# Wellington Lane Walking & Cycling Scheme

## Part 8 Public Consultation Report

Project Title:	<b>Wellington Lane Walking and Cycling Scheme</b>		
Document Title:	<b>Statutory Consultation Report</b>		
File Ref:	<b>180201-DBFL-XX-XX-RP-S-0004</b>		
Status:	<b>P1 - Information</b>	Rev:	<b>3</b>
	<b>A - Approved</b>

Figure 4-2: Students for the Bishop Galvin NS Travel Distance to the School (SRTS Report)

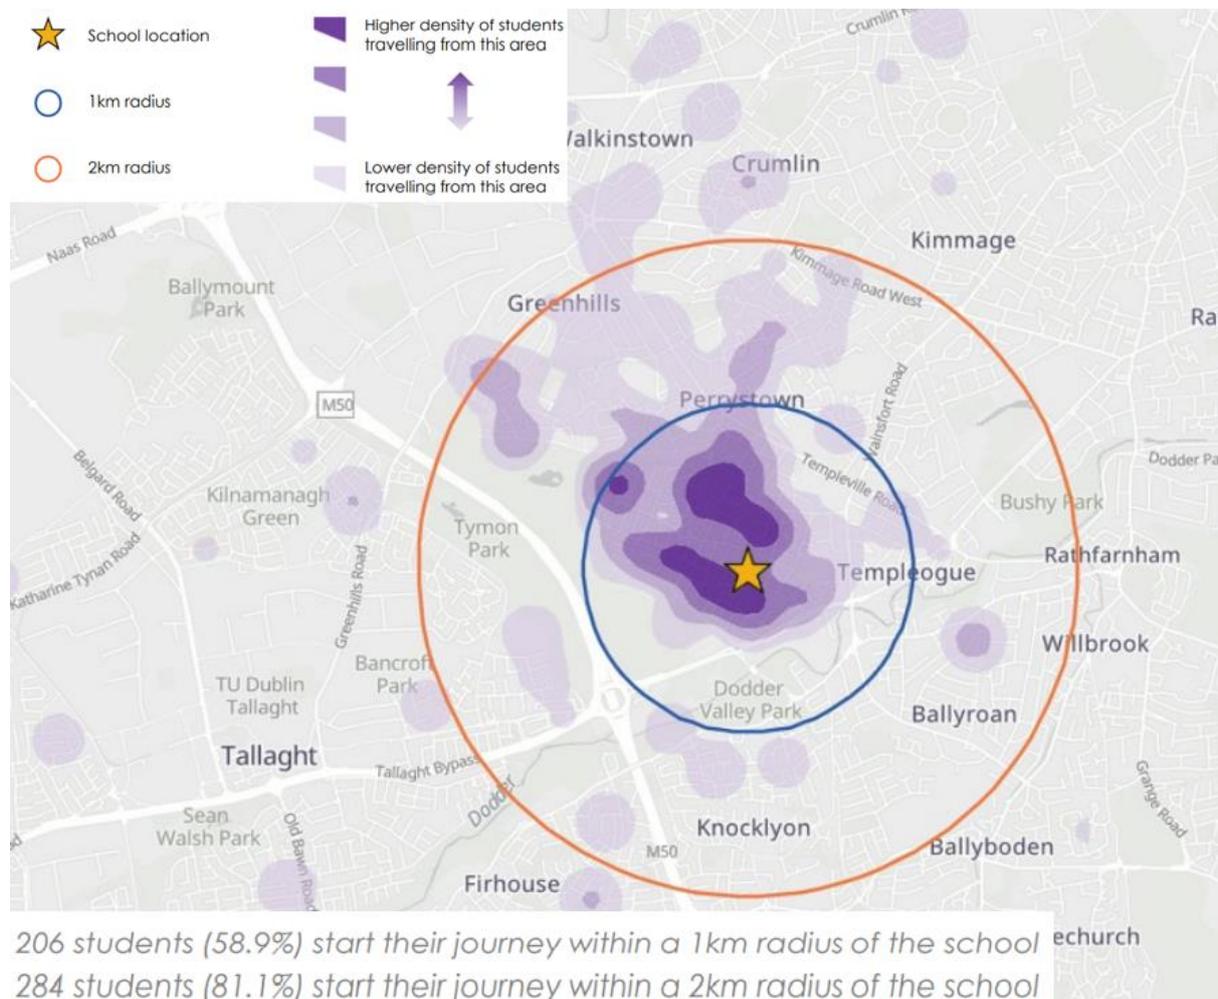
**General Comment 1:** The majority of submissions made in relation to parking along the scheme noted the requirement to maintain parking outside schools for school drop off and collection. Some submissions highlighted particular concerns within the Rossmore estate, outlining that traffic congestion will be exasperated as a result of the removal of parking along Rossmore Road and that vehicles will park in the residential estate roads adjacent to Rossmore Road and block driveways in these locations. Submissions outlined that this additional parking will have a detrimental impact on the overall safety within the Rossmore estate.

**Response to General Comment 1:** As part of this scheme, it is proposed to remove the ability to park outside schools within the study area. The schools within the study areas have noted support for this scheme and provided submissions to outline this support. The previous and current parking outside the schools presents a dangerous scenario for school pupils travelling to and from school. Cars frequently block visibility and park within the road carriageway, creating unsafe access for all users. Idling vehicles (during drop off and collection outside the school) also contributed to general health issues for school pupils through emissions exposure. For parents who do require a vehicle to drop off/collect from schools, there are a number of opportunities to park and stride to the schools within the study area, including car parks of Tymon Park for both MacDaras and Riverview Educate Together NS , as well as the Spawell Car Park for Bishop Shanahan and Galvin and MacDaras Community College. This would address the existing/potential parking concerns from residents for drop off/collection within residential estates.

With regard to the Bishop Galvin NS located along Rossmore Road, a Safe Route to School Delivery Plan report has been undertaken by An Taisce and the NTA. This report highlighted that 81% of pupils travelling to the school are located within a 2km radius of the school, as illustrated within the heat map in Figure 4-2.

It is considered, therefore, that parking outside the school is not required and should be removed in order to provide a safer environment for school children walking and cycling to school. A park and stride option is considered to be the preferable solution for schools within the study area.
